UNITED STATES
NUCLEAR REGULATORY COMMISSION
WASHINGTON, D. C. 20555

SUBJECT: BOARD NOTIFICATION: ALLEGATIONS RELATING TO IMPROPER
CONSTRUCTION PRACTICES ON COMANCHE PEAK -IN CONDENSERS
(BOARD NOTIFICATION NO. 84-124)

Comanche Peak Units 1&2
Docket Nos. 50-445/446

9  Exhibit 1 just referred to
10 follows.)

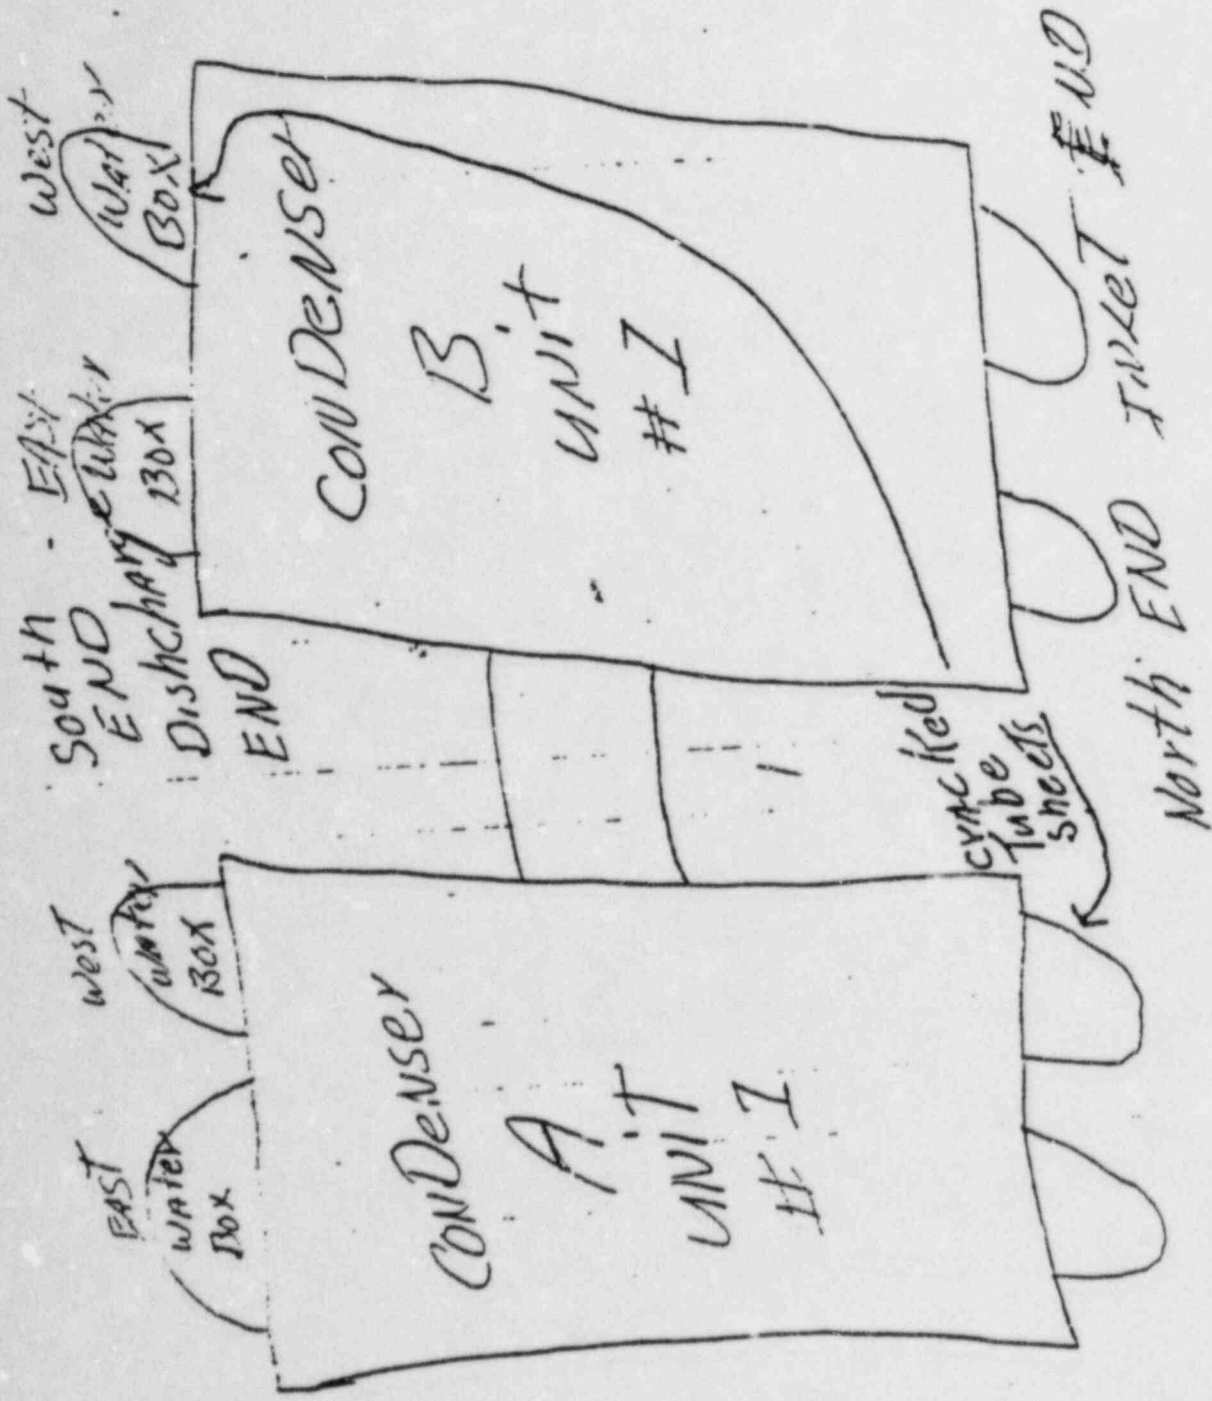
15 Here is your water boxes right here and your
16 condensers. All right, in condenser A on the inlet end on
17 the west box and it is in three sections. You have got
18 some cracked tube sheets in here. Back there you have got
19 some cracked tube sheets. You have got overrolled tubes or
20 barely overrolled. They are supposed to be rolled 669
21 thousand is a perfect roll inside reading. They allow us
22 to go to 671 thousand. We went up 90-some thousands.

12 [REDACTED] Okay. Condenser B, Unit 1,
13 west discharge water box and you have got a cracked tube
14 sheet. Also, the tubes are overrolled severely.

15 On the east water box, condenser B, discharge
16 end, you are heavily overrolled and you undoubtedly have
17 got quite a few cracks in it. I can swear to that. I know
18 you do because it swelled up so big.

19 Overroll on the west box, condenser A, Unit 1,
20 discharge end.

21 East water box, discharge end, condenser A,
22 you are still leaking, and overrolled.

2 Condenser A, Unit 1, intake box, the west box,
3 you have got cracked tube sheets.

12 ([REDACTED] Exhibit 2, the document just
13 referred to, follows:)

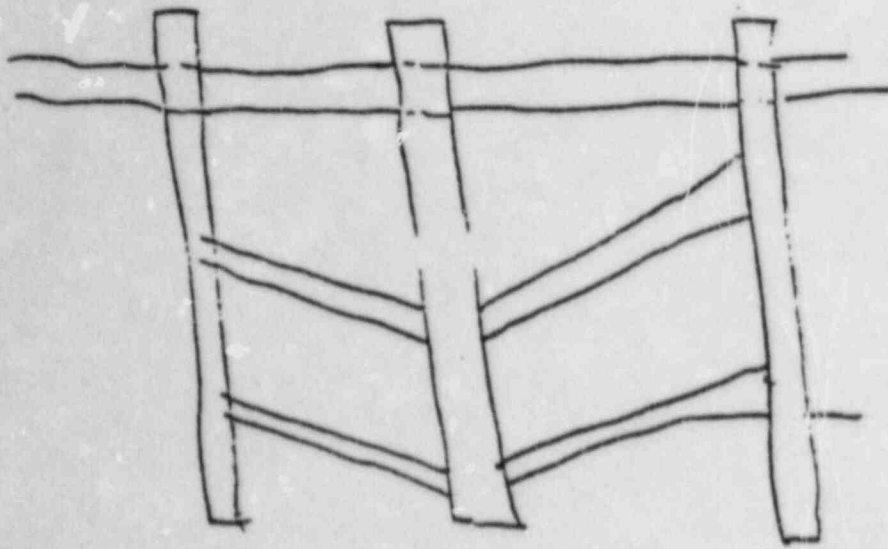
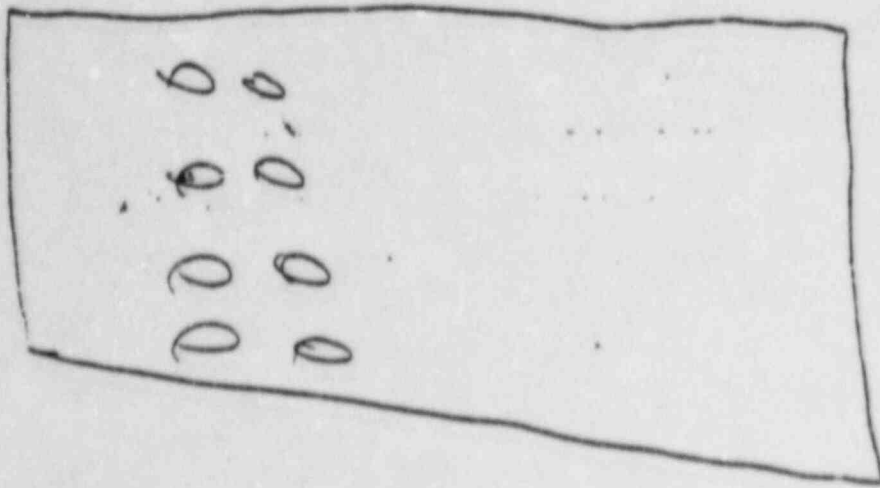
7 This is a real good example. These tube
8 support sheets came in. We laid them on top of each other
9 and we put dowel pins in them. Some of the holes was
10 three-eighths of an inch off; from the others, you know.

11 So I called [REDACTED] and I told him, I said we
12 are going to have a problem here. These holes are way off.
13 Well, he calls Westinghouse, and Westinghouse says oh,
14 there is nothing to it. [REDACTED] says, [REDACTED], they are just
15 three-eighths of an inch off. I said well, you have got
16 three foot from the center of one sheet to the other, and
17 when you start off with three-eighths of an inch off you
18 are off quite a ways when you get to the other end, you
19 know, the three foot.

20 If you go three-eighths of an inch off, over
21 here you might be an inch and a half off, and by the time
22 you turn it back in then automatically you are going to
23 need the other way. So you are binding every sheet. You
24 are cutting into the tubes.

1 certain amount of clearance so that tube can roll
2 without binding. They are cut in two here.

4 [REDACTED]: This is Unit 1 and Unit 2 A
5 and B condensers, the main condensers. This is what I am
6 talking about. I am not talking nothing about the
7 Auxiliary condenser. Everything is the main condensers.
8 There is supposed to be something like 39 thousand
9 clearance in the tube support sheets so that your tubes
10 can expand in its track without binding. Now your main
11 tube sheet is 10 thousand before they roll these.

7 ([REDACTED] Exhibit 3, the document just
8 referred to, follows:)

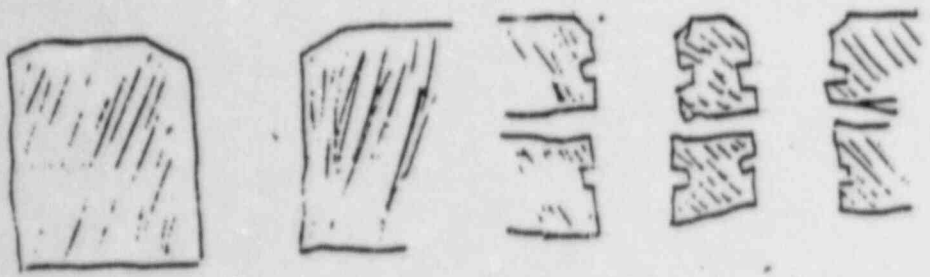
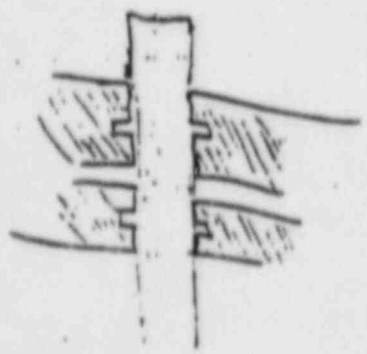
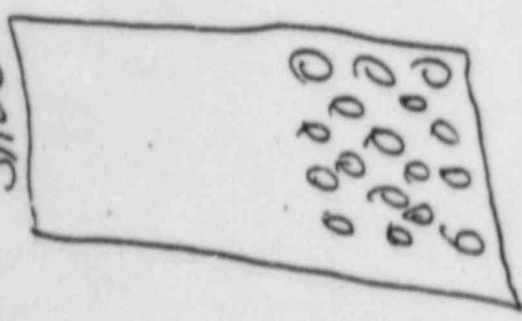
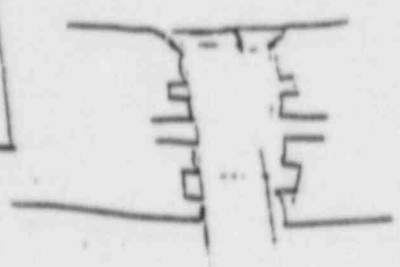
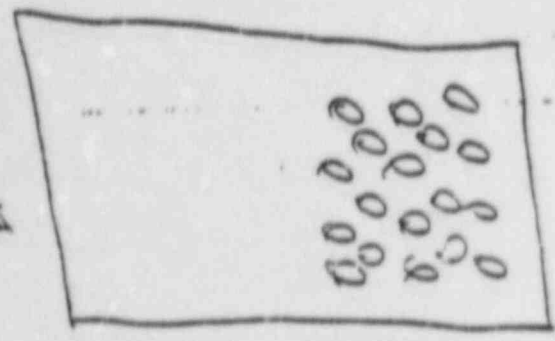
5 ██████████: On your inlet tube sheets.
6 They are 1/32nd flush, the tubes, and they are flared. If
7 they are sticking out, you get a build-up between your
8 tubes. So when we flared these we busted a lot of tubes,
9 or quite a few of them as a matter of fact.

10 Now this chart, and it sticks out, but we cut
11 them down like a half inch so it would look half way
12 decent. But when we was flaring these tubes they was
13 busting pretty bad, and the reason they was busted so bad
14 in this one area is because the counterbore in your tube
15 sheet where, it, allows the flare to flare out was way
16 overboard. So in order for us to flare it tight enough we
17 busted a tube, and the ones that didn't bust we hadn't
18 flared it tight enough. When you don't flare them tight
19 enough you get a build-up between your sheet and your
20 tubes and it eats the tube off.

11 ([REDACTED] Exhibit 4 follows:)

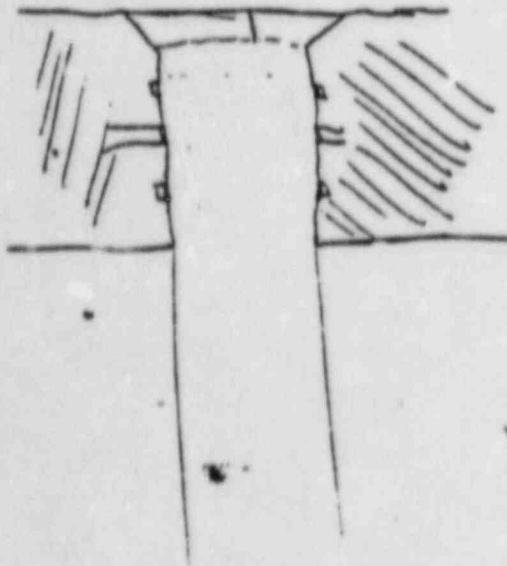
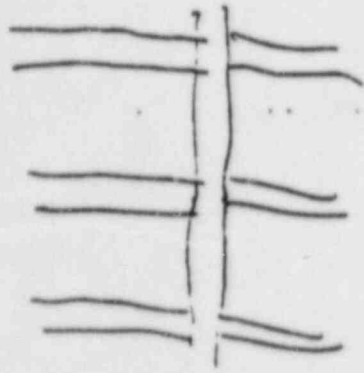
2 [REDACTED]: We have got cracks here on
3 these flares.

5 [REDACTED]: The flare is the intake end of
6 all condensers and your water boxes.

8 [REDACTED]: Yes, Glen Rose, Texas at
9 Comanche Peak. Most of them is in condenser A on the inlet
10 end east water box middle way of the sheet.

20 ([REDACTED] Exhibit 5A and 5B follows:)

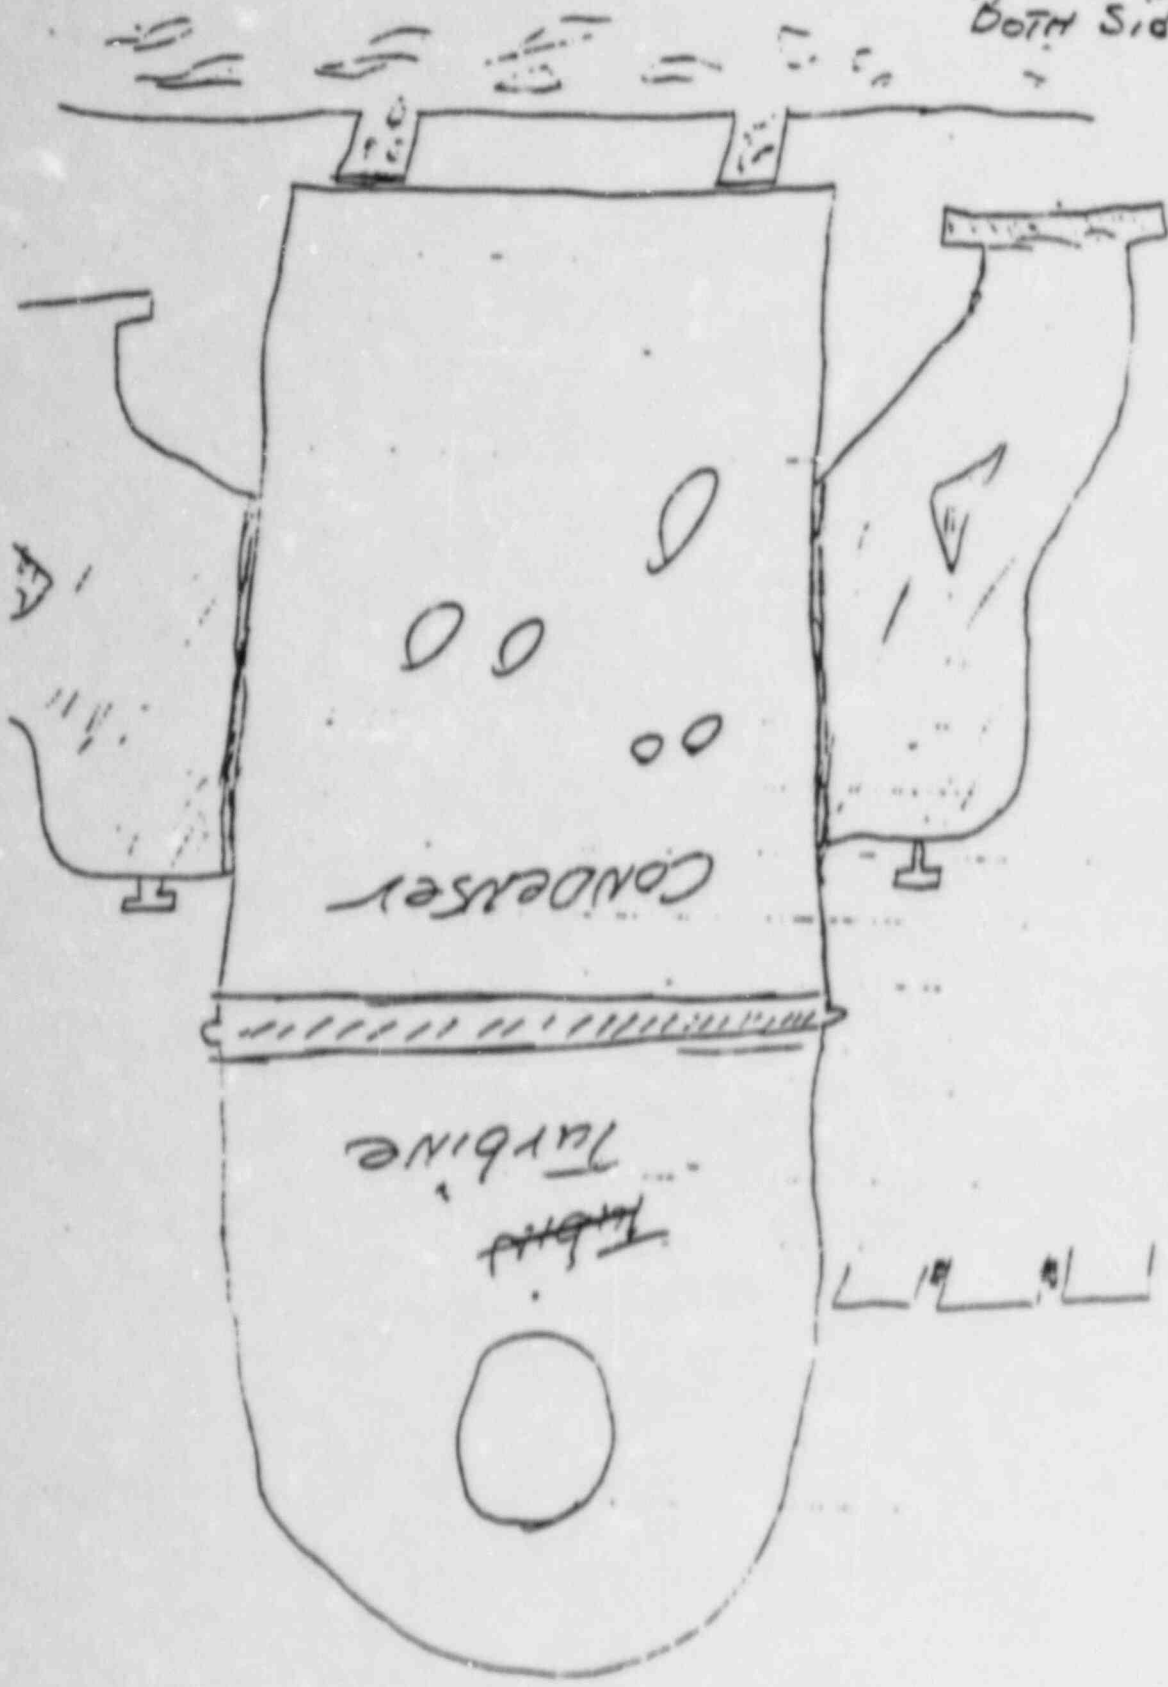
11 They took a reading and they was three-eighths
12 of an inch off alignment. So they went up here and they
13 took jacks and they started jacking and, boy, jacked it
14 all the way over to where they want it and they release
15 it, that little old expansion joint, and pulled it back.
16 The little expansion joint was a one loop and it was an
17 eighth of an inch thick and it had one little fillet weld
18 on each side of it, real weak. They put several, several
19 tons on it. I will show you what it looked like.

4 [REDACTED]: (Referring to Exhibit 5B) Oh,
5 this is the expansion joint I was talking about with the
6 fillet welds. It is a real small stainless steel 1/8th
7 expansion joint and it has got two small, little fillet
8 welds there.

11 [REDACTED]: We put several, several, I
12 think two or three hundred tons against it.
